**RECOMMENDATIONS OF THE QUEEN ANNE MAGNOLIA  
SEATTLE DESIGN REVIEW BOARD  
TO DPD DIRECTOR**

**November 19, 2008**

**Project Number: 3009234**

**Address: 601 Westlake Ave. N.**

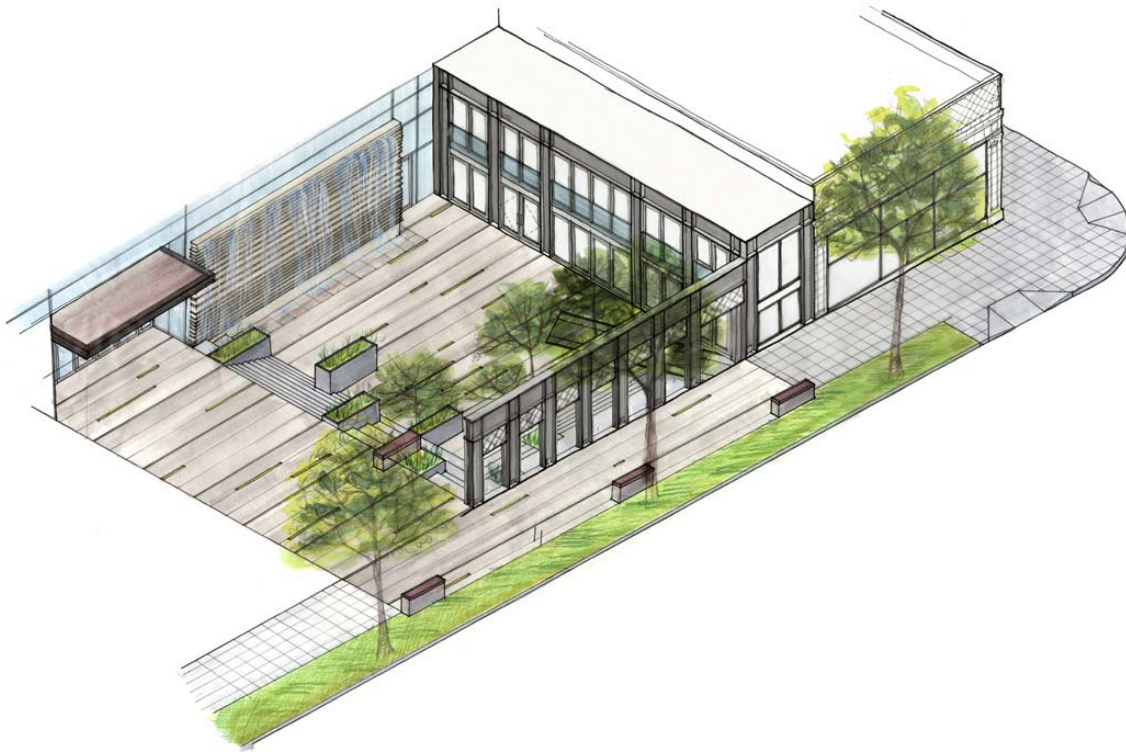
Attention was given to the Ninth Ave. streetscape environment as it is expected to be pedestrian in nature; a refuge from the busy Westlake and Mercer thoroughfares. It is recommended that the vent shaft be moved to the western side of the driveway so it is further away from the pedestrian activities at the northeast corner.

In looking at the relationship of the historic facades to the glass curtain wall structure behind them the Board recommended the applicant look at the proposed white spandrel panels to determine if another technique, such as fritted glass, would be a more pleasing expression.

Discussion of alley remnant expression on the north façade devising two building expressions led to direction that measures be taken to make it stronger. They discussed many possible approaches, including departures for a structural building overhang and reached no consensus on the approach to be taken; instead stating a design objective.

The Board discussed the two corner glass “point” elements in the design and determined that the northeastern one at the corner of Westlake and Ninth should be made wider and recommended granting a departure from the code limits for structural building overhangs to accomplish this.

The Board observed and the applicants agreed that the historic terra cotta wall element should not reach the glass curtain wall of the building behind it in exactly the same plane.

The Board debated the design of the screen wall along the property line in front of the plaza area on Mercer St. and decided that the easternmost segment of it should be removed.

1. Move the vent shaft to the western side of the driveway.
2. Look at the proposed white spandrel panels to determine if another technique, such as fritted glass is more appropriate and pleasing.
3. The alley remnant expression on the north façade devising two building expressions shall be modified to make it a stronger element.
4. Make the corner glass “point” element at the northeast corner wider and more prominent.
5. The historic terra cotta wall element should not reach the glass curtain wall of the building behind it in exactly the same plane and instead shall be offset.
6. The easternmost segment of the screen wall along the property line in front of the plaza area on Mercer St shall be removed.
